**CDM: Recommendation Form for Small Scale Methodologies (version 01)**  
*(To be used for presenting questions/proposals/amendments to the simplified methodologies for small-scale CDM project activity categories)*

<i>Date of SSC WG meeting:</i>	20–23 March 2012, SSC WG 36
<i>Title/Subject (give a small title or specify the subject of your submission, maximum 200 characters):</i>	Applicability of AMS-III.Q for waste heat recovery from reclaimed water for space heating application
<i>Indicative methodology to which your submission relates (refer the items of Appendix B of the Simplified Modalities and Procedures), if applicable.</i>	AMS-III.Q “Waste energy recovery (gas/heat/pressure) projects”
<i>Name of the authors of the query:</i>	Catherine Huang Institution: A&T Carbon Asset Co., Limited <a href="mailto:Catherine.huang@atholdings.com">Catherine.huang@atholdings.com</a>

The diagrammatic drawing of the project was attached for easily understanding.

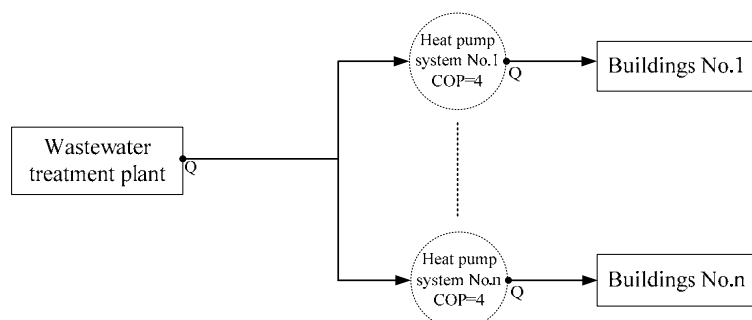
- 1) It is stated that “(3) The heat produced with the recovered waste heat can be measurable.” First, please clarify if there is other distribution system (DHN) mixes with the heat pump system. And, please explain whether the measurement is made at the recipient end (final users of the distributed heat) and emission reduction is estimated based on equivalent fossil fuel use displaced at the final users? Also, if the recipient plant (district heating system) is connected to different heat generating plants, how emission reduction would be calculated? If the measurement is based at supply end, how the emission reduction can be attributed to the displacement of fossil fuel use at the final users?

1. No other distribution system (DHN) mixes with the heat pump system. The waste heat from the reclaimed water of the existing wastewater treatment plant is the only heat source of the project activity.
2. As the final users of the project are the households, the direct measurement is difficult to achieve. So, the proposed measurement is made at the outlet of heat pump systems. Meters will be installed in a manner that ensures that only the quantity of heat supplied for room heating purposes is metered (Refer to AM0058).
3. The recipient plant (households in buildings) is not connected to different heat generating plants; the only heat source is the waste heat of reclaimed water.
